# **Staff Report**

## Infill Housing Design Review Committee

File Number: 12-E-24-IH

**Location:** 202 Hiawassee Ave. Parcel ID

FLOOR PLAN 'A'&'C 35' WIDE PLAN

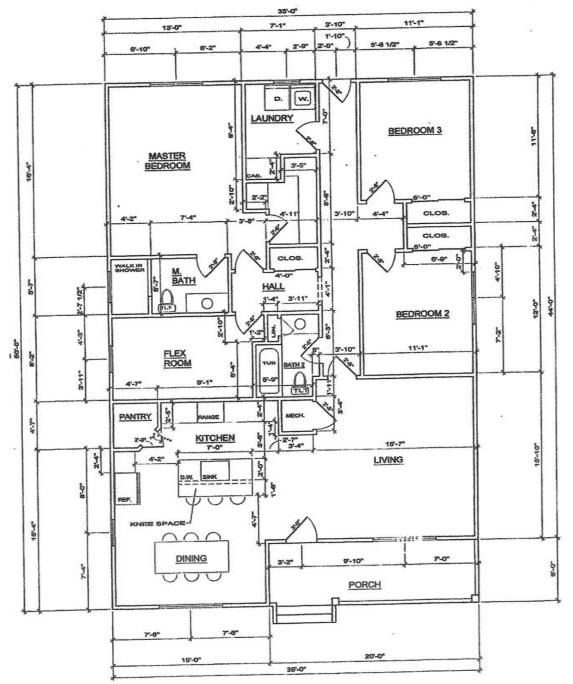
- 1. The new house is proposed to be set 20' from the front property line. The average front setback of the blockface is 29.8'; however, the blockface is long and features a wide variety of front setbacks. The three adjoining new houses will create a consistent front setback pattern. The final site plan should include a walkway from the front of the house to the street.

- 3. Infill Housing design guidelines recommend that on lots without alleys, new driveways should be at least 20' behind the front façade of the infill house with access limited to one lane between the street and the front façade. Parking is currently proposed for the front yard and should be revised to meet guidelines. The final site plan should meet City Engineering standards.

- 4. The three-bay façade is similar in scale and height to the context.
- 5. The design includes a 6' deep, half-length front porch recessed under the primary roofline, supported by two square columns. Guidelines typically recommend a porch 8'-12' deep. The porch depth should be revised to meet guidelines.

- 6. Guidelines recommend window and door styles be similar to historic houses on the block, with similar placement and ratio of solid to void, and also note that "contemporary windows such as 'picture windows' should not be used." The design primarily uses paired picture windows, which are incompatible with the context where 1/1 single-hung windows are most common. The front and rear elevations contain sufficient transparency. The right elevation contains one paired picture window, and the left elevation features a single-hung window and a small picture window. Picture windows should be revised to be single-hung, and one window should be added to the right and left elevations, with details submitted to staff for approval.

- 8. The materials for the roofing and siding were not provided, and the foundation appears to be a concrete slab. The slab foundation should be clad in stucco or parge-coated to match the context. Siding should be a horizontal lap siding with an overlap similar to wood clapboard patterns instead of Dutch lap or flush panel siding.

- 9. The site plan indicates a tree in the front yard, and the final site plan should also include a tree in the rear yard.
- 10. The three adjoining new houses are sufficiently differentiated from each other.

Staff recommends approval of Certificate 12-E-24-IH, subject to the following conditions: 1) final site plan to meet City Engineering standards; 2) modifications to the porch to meet Infill Housing guidelines; 3) use of lap siding with an overlap instead of Dutch lap or flush panel siding; 4) final site plan to include a walkway from the front door to the street; 5) revisions to parking to meet design guidelines and avoid the front yard; 6) revisions to façade and side elevation windows design and placement, with approval by staff; 7) final site plan to include one tree in the front and rear yards.
